WELL API NO. 30-025-28352
5. Indicate Type of Lease STATE <input checked="" type="checkbox"/> FEE <input type="checkbox"/>
6. State Oil & Gas Lease No. 19520
7. Lease Name or Unit Agreement Name South Hobbs G/SA Unit
8. Well Number 149
9. OGRID Number 157984
10. Pool name or Wildcat HOBBS; GRAYBURG-SAN ANDRES
11. Elevation (Show whether DR, RKB, RT, GR, etc.) 3620' RKB

2. Name of Operator
Occidental Permian LTD

Objective: Plugback ZnH and below (within same pool).

SHU 149

Proposed WBD

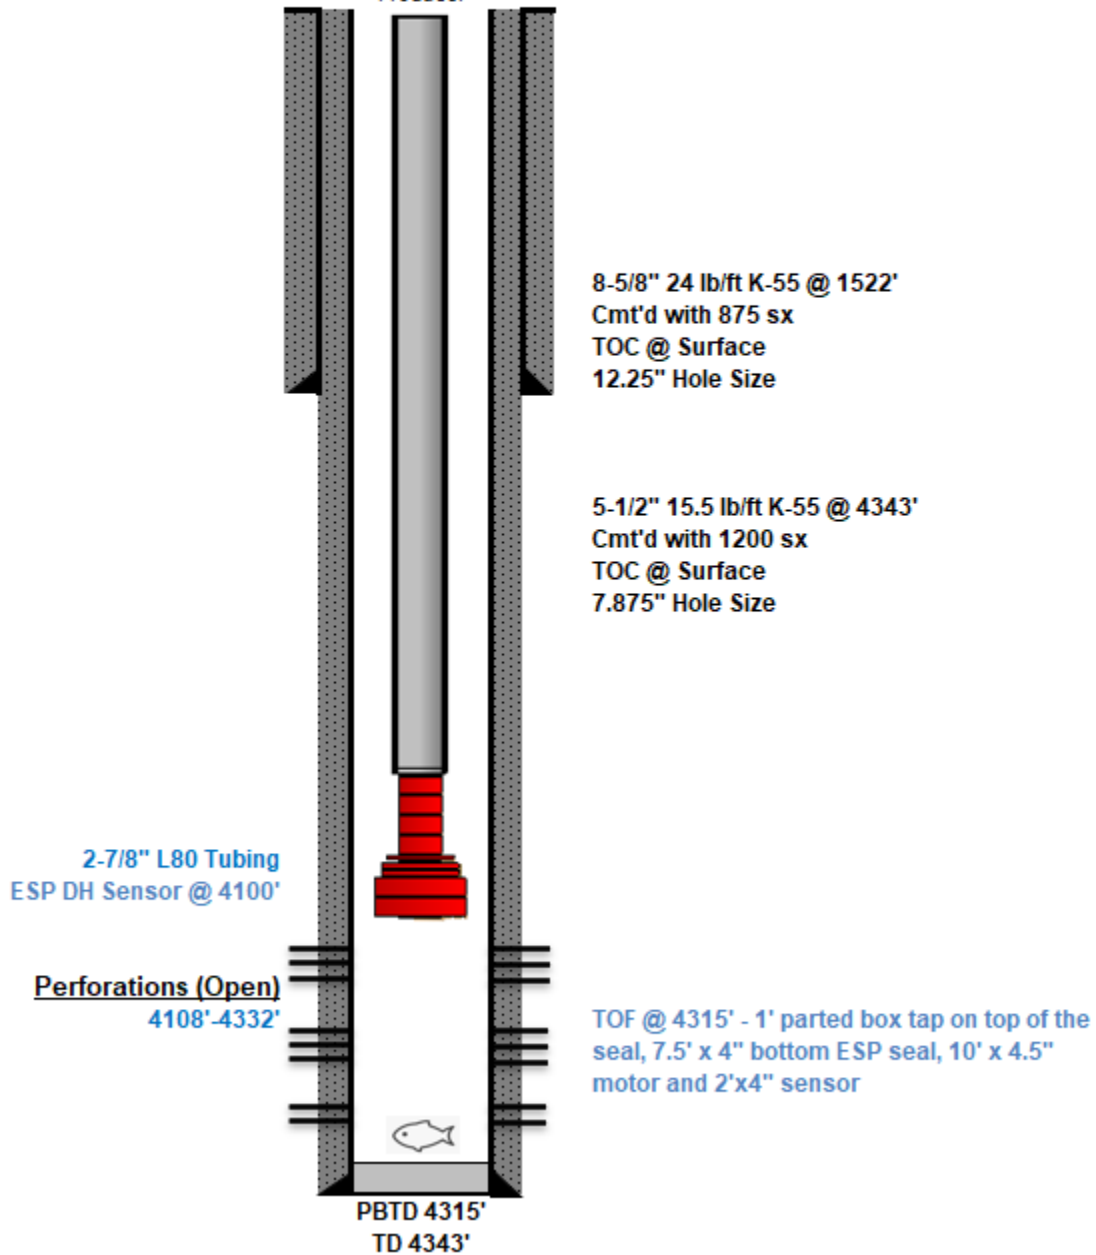
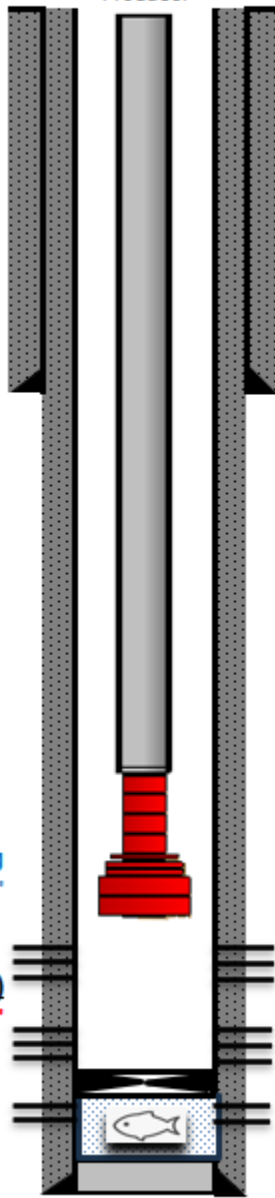
Plugback ZnH and below w/ pea gravel
and CIBP set at 4287'

Objective: Plugback ZnH and below.

1. Pull production equipment.
2. Dump pea gravel from TD @ 4343' to 4290'
3. Set CIBP at 4287'.
4. Install production equipment.
5. Return well to production.
